## Assessment report to Sydney Central City Planning Panel

Panel reference: 2017SWC068

### Development application

<b>DA number</b>	SPP-17-00007	<b>Date of lodgement</b>	27 March 2017
<b>Applicant</b>	The Wickwood Property Group Pty Ltd		
<b>Owner</b>	R, M, E and M Haddad		
<b>Proposed development</b>	Construction of 2 residential flat buildings (8 storeys) comprising 170 apartments, 236 car parking spaces in 2 basement levels and associated civil and landscaping works		
<b>Street address</b>	Proposed Lot 1 in subdivision of Lot 74 DP208203 59 Cudgegong Road, Rouse Hill		
<b>Notification period</b>	23 July to 6 August 2018	<b>Number of submissions</b>	1 (in support)

ISSUE:  
**F**  
SHEET :  
**DA-A208**

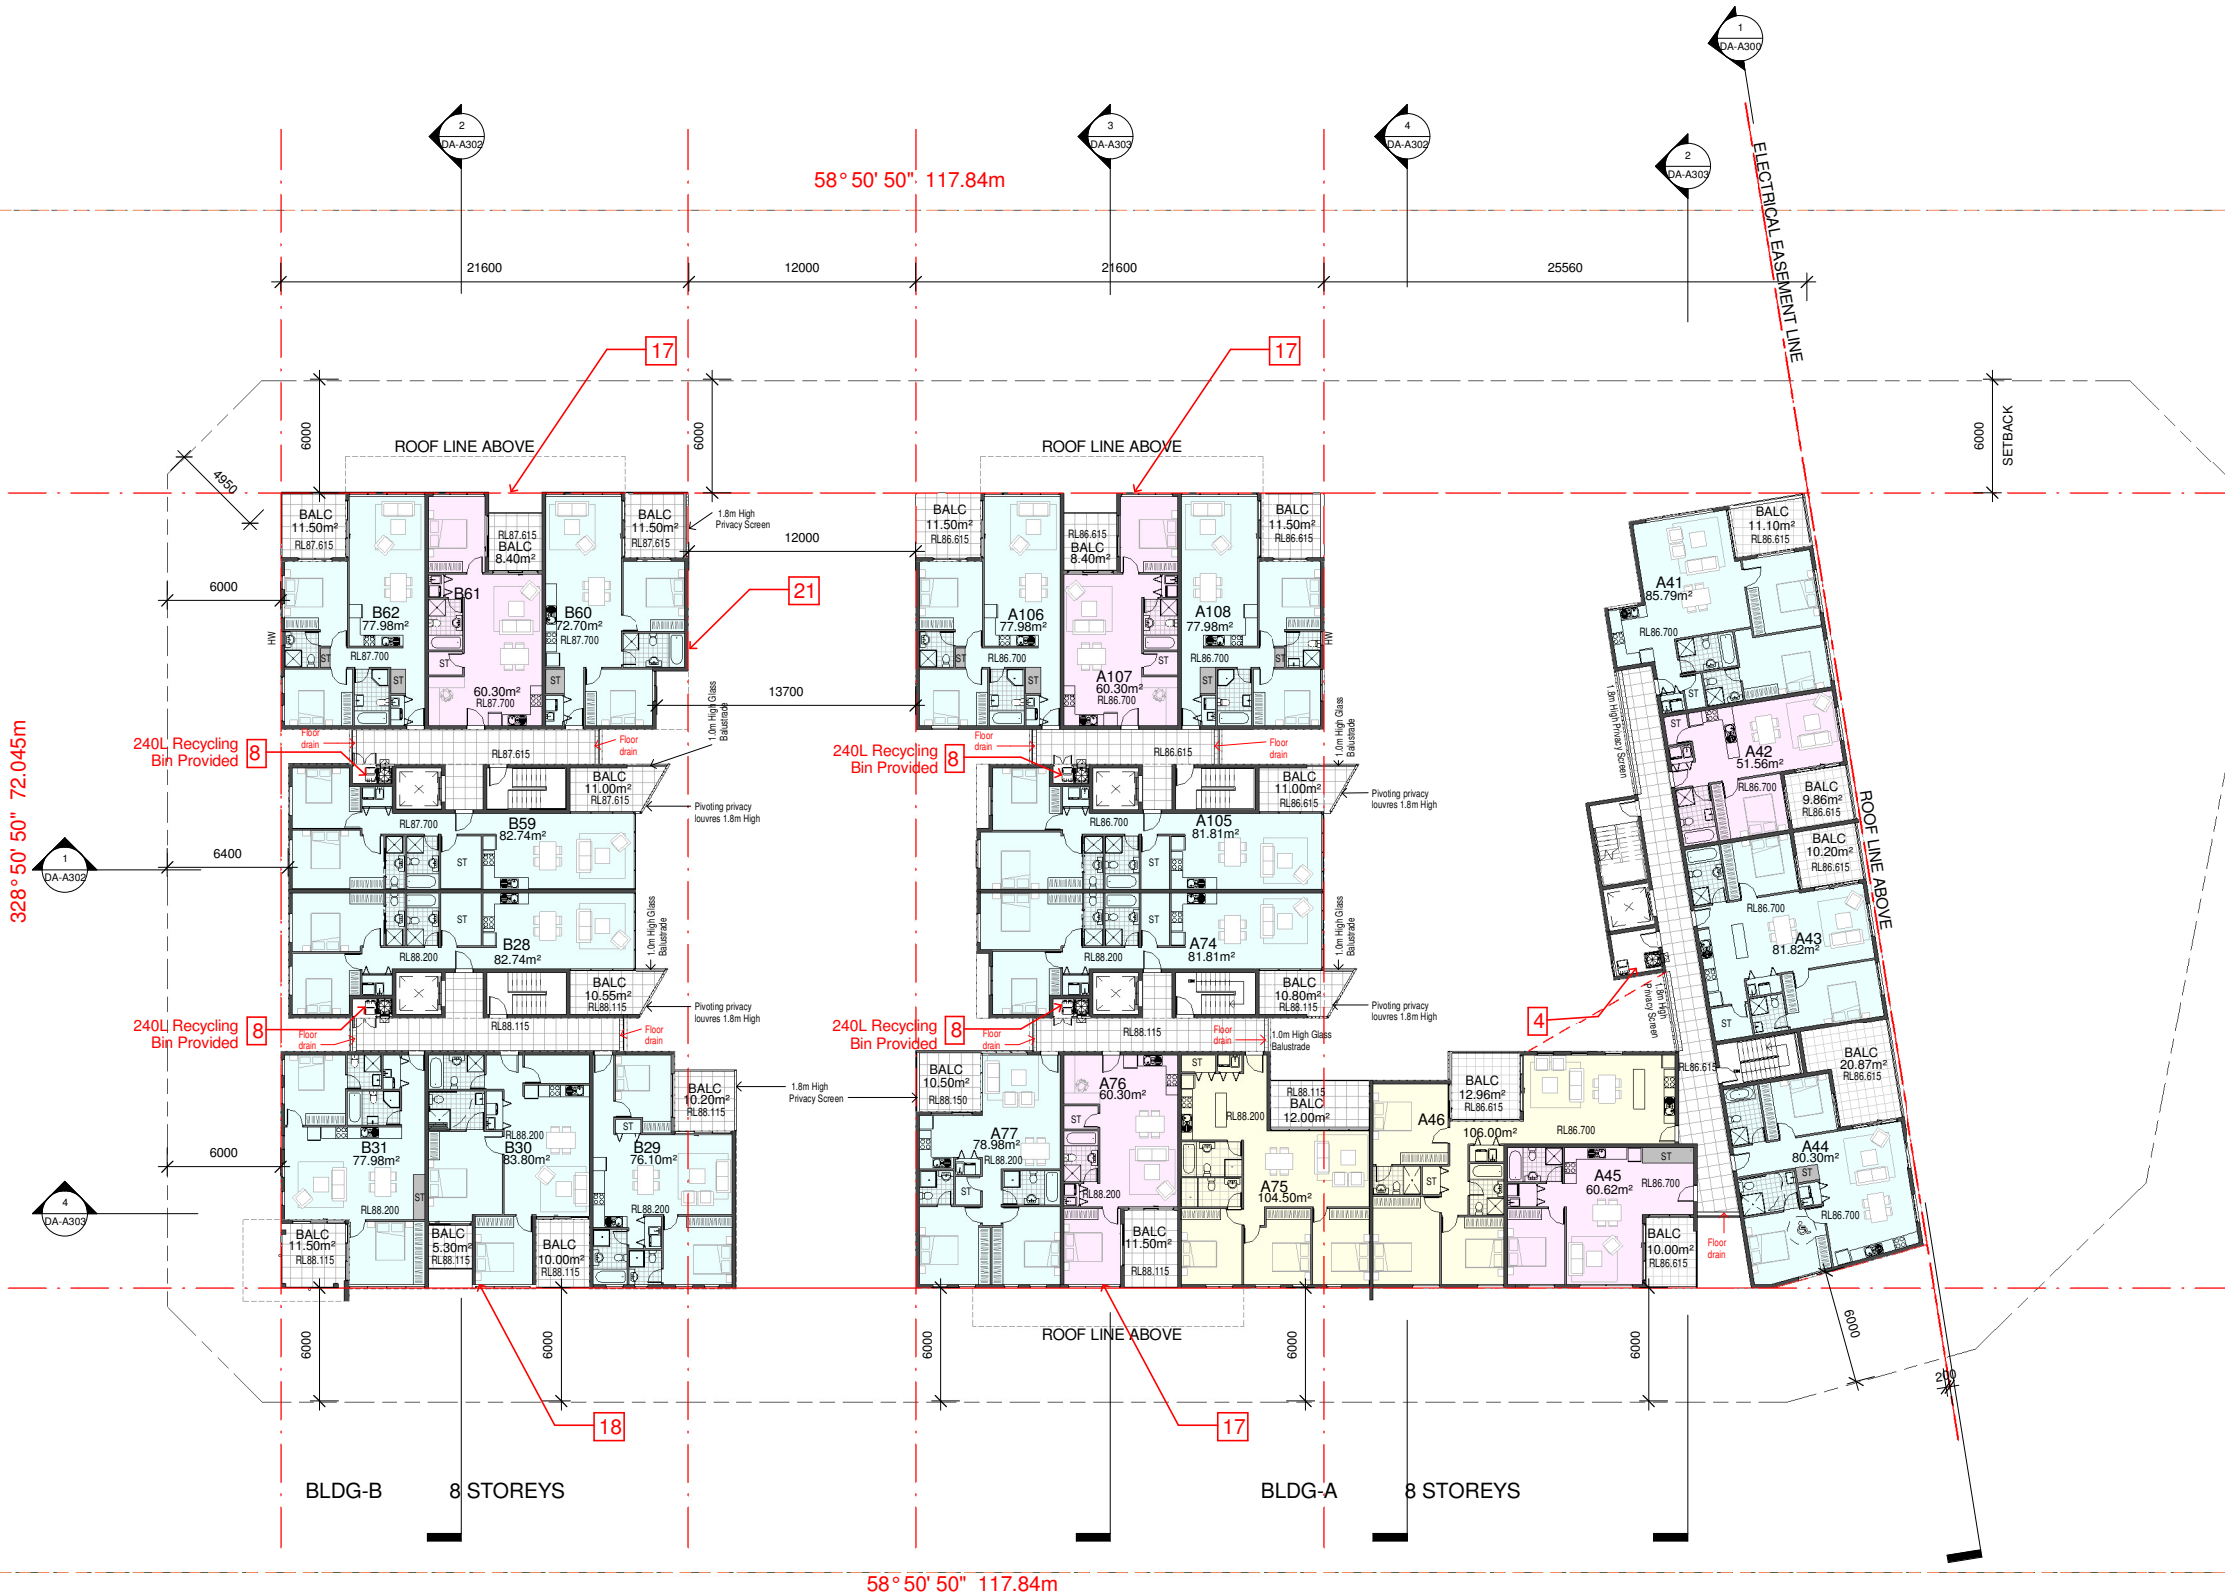
- 4.Building-A residents access to recycling bins located at the top of the stair well and adjacent to the lift core from Level 1 and above added.
- 5.Waste room access adjacent to the driveway ramp relocated.

- 16.Redesigned Building A to achieved solar access requirements to the communal open space. Fire stairs and lift relocated,access ramp added to access COS and redesigned of the unit layouts.

- 19.Building A roof plan adjusted and roof overhang deleted.
- 20.Skylights provided on Unit A45,A76,A77,B30& B31 but is not included in the solar calculation that recieved minimum 2hrs of sunlight.
